Notification of Class I Permit Modification for the Los Alamos National Laboratory

(LANL) Hazardous Waste Facility Permit to Add Structures to a Container Storage

Class 1 Permit Modification Notification Addition of Structures within Technical Area 54, Area G, Pad 11, Dome 375 Los Alamos National Laboratory Hazardous Waste Facility Permit

> ENV-RCRA-12-0163 LAUR-12-22808

Figure 36: TA-54, Area G, Pad 11

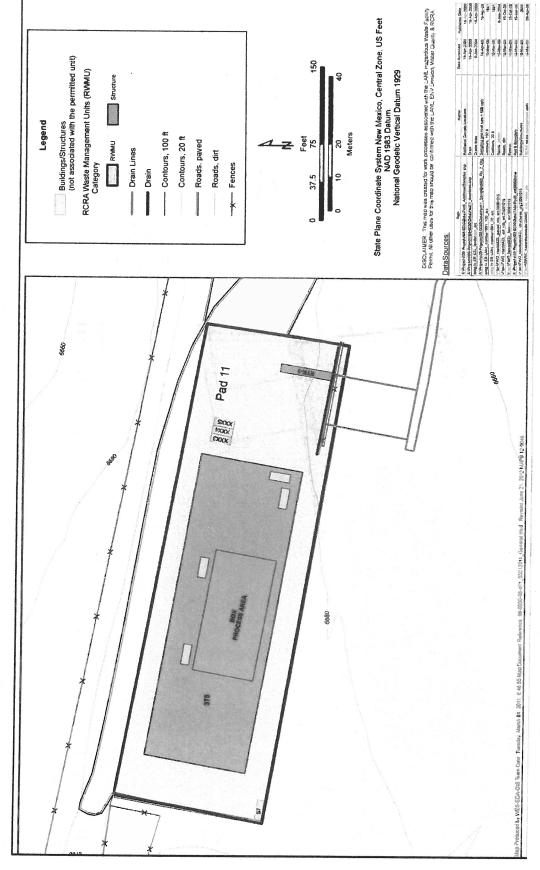
The modification adds structures to the container storage unit at Technical Area (TA) 54 Area G, Pad 11. Structures that will not be used to manage hazardous waste have been added within Dome 375 located at TA-54, Area G, Pad 11.

Descriptions of the structures have been added to Section A.4.2.9 in Attachment A, TA – Unit Descriptions; and Section 2.0 in Attachment G.12, Technical Area 54, Area G, Pad 11 Outdoor Container Storage Unit Closure Plan. Revised figures are Figure 36 in Attachment N, Figures; and Figure G.12-1 in Attachment G.12, Technical Area 54, Area G, Pad 11, Outdoor Container Storage Unit Closure Plan.

Figure G.12-1: Technical Area 54, Area G, Pad 11 Outdoor Container Storage Unit Grid Sampling and Additional Sampling Locations

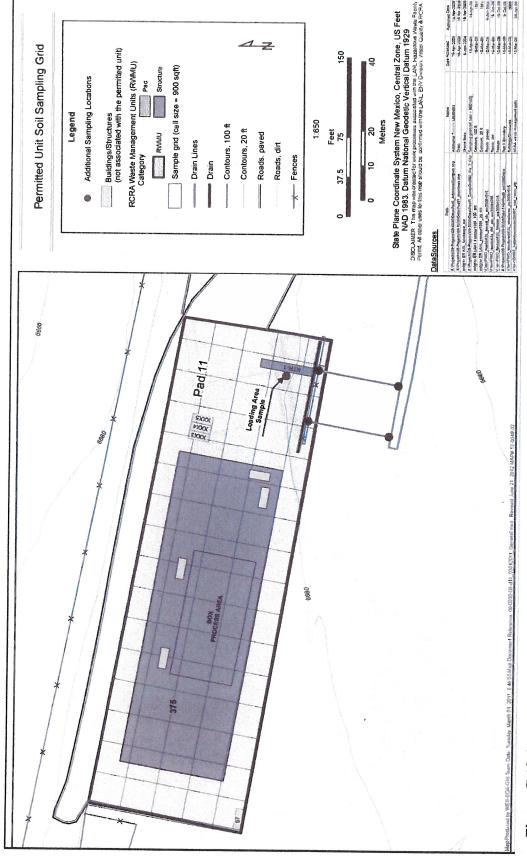
The structures will not be used for waste management activities; therefore, changes have not been made to the proposed sampling locations or the structural assessment sections of the closure plan or to the list of active units in Attachment J, *Hazardous Waste Management Units*.
